JOB NAME: NEW ELEMENTARY SCHOOL #17

DETAILS OF: SECTION - 1&2 ICF WALL LAYOUT

TEXAS REBAR, LLC 817-487-1672

JOB NAME: NEW ELEMENTARY SCHOOL #17  
JOB NO: 22102  
DETAILS OF: ICF WALL REINFORCEMENT  
DATE: 08-25-22  
DETAILER: SSSTR  
DRWG: M09  
TEXAS REBAR, LLC 817-487-1672

**TYPICAL DETAILS**

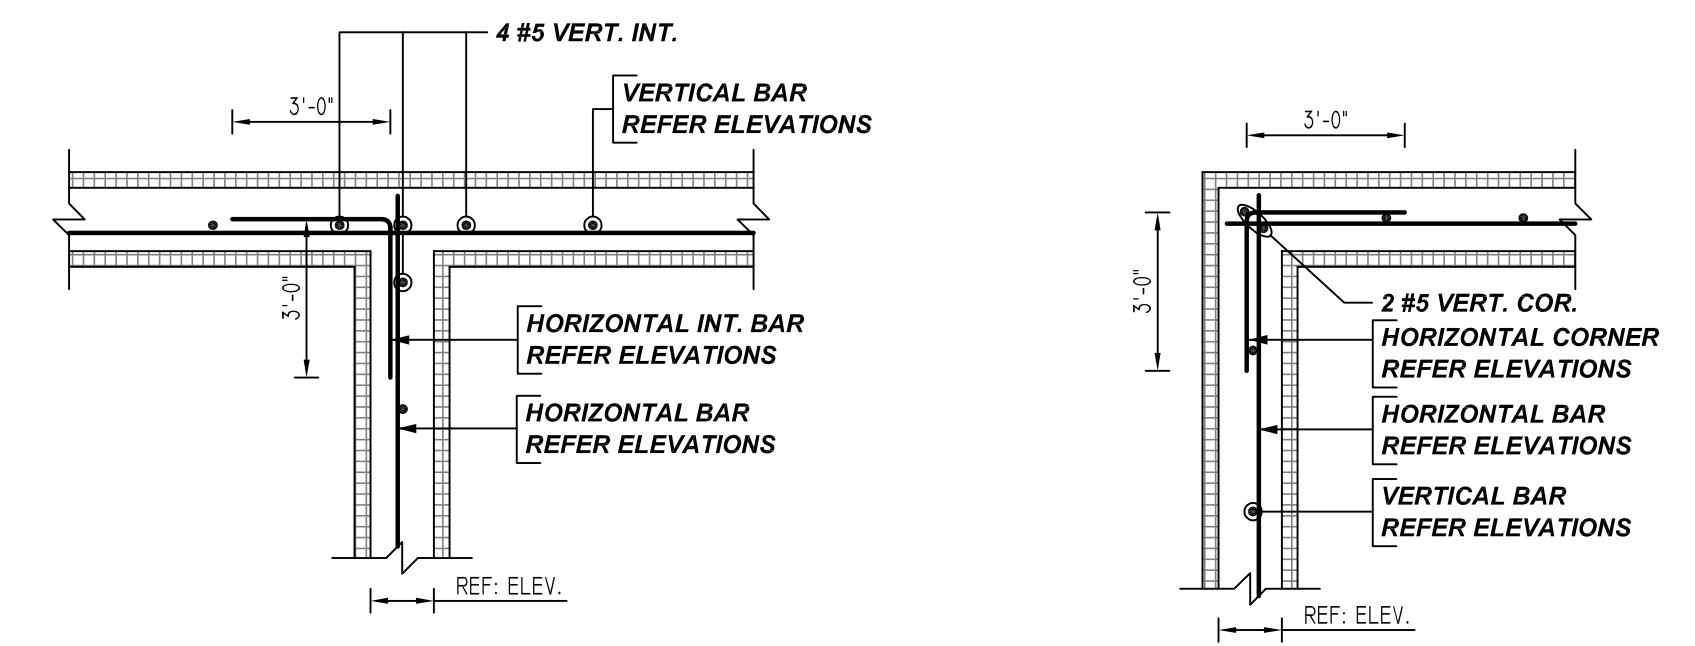
SCALE: 1/2" = 1'-0"  
REF: 1/S5.01 (DT.05/20/22)  
A/E PLEASE VERIFY THE BAR ARRANGEMENT
